Memorandum – Specialist input: Healthy Waters

Subject: FTA159 – Delmore Fast Track – Auckland Council Application Reference: BUN60444768

Date: 25 June 2025

Figure 1. SMP - Figure 14: Treatment Train flow chart for BPO (McKenzie and Co – Feb 2025)

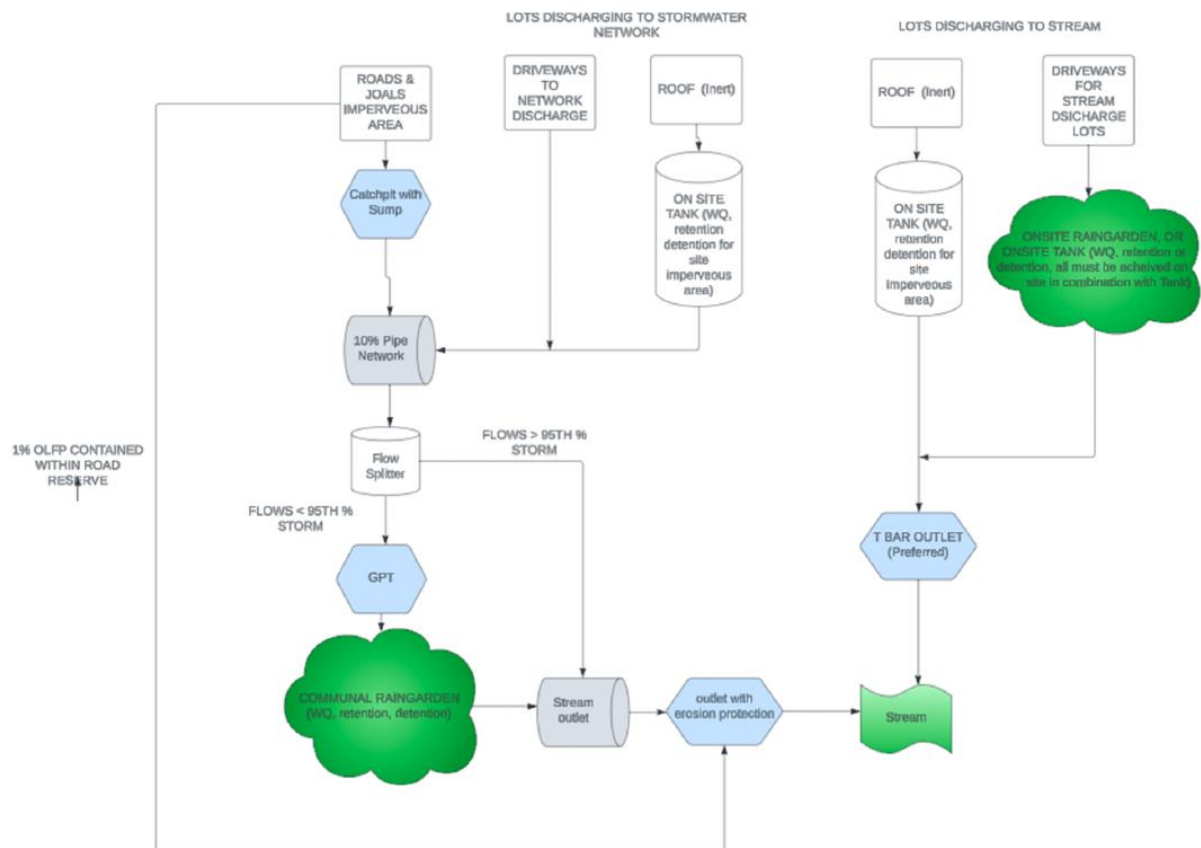
- 3.3 The SMP outlines a Treatment Train approach for stormwater management for the development as outlined within Figure 1. This does not fully align with the descriptions provided in the Infrastructure Report which may result in inappropriate implementation of the stormwater management solution for the development area. In relation to the roof tanks (plumbed for non-potable reuse), the implementation is described as optional. This requires clarification to ensure the stormwater management solution is implemented appropriately.
